PRATT & WHITNEY CANADA
SERVICE BULLETIN

P&WC S.B. No. 41119R1

TURBOSHAFT ENGINE
IGNITION EXCITER - REPLACEMENT OF

PT6C-67C, PT6C-67C1

Ignition Exciter - Part Progression
Figure 1

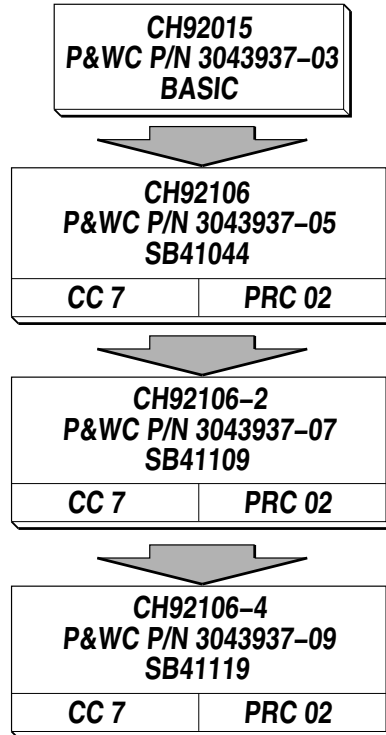
The ignition exciter spider switch is no longer available.

The ignition exciter spider switch has been obsoleted.

Replace the ignition exciter with one that has an available spider switch.

Replace the ignition exciter with a new one.

<u>New P/N</u>	<u>Keyword</u>	<u>Old P/N</u>	<u>Qty</u>	<u>Est. Unit List Price (\$US, 2021)</u>	<u>Instructions Dispositions</u>
	Ignition Exciter (0AFL4) P&WC P/N 3043937-07	CH92106-2	1		(A)(B)
CH92106-4	Ignition Exciter (0AFL4) P&WC P/N 3043937-09		1	Quote	(A)

(A) TWO WAY INTERCHANGEABLE (ATA200 Explanation Code 02): The old or the new parts can replace the old or the new part.
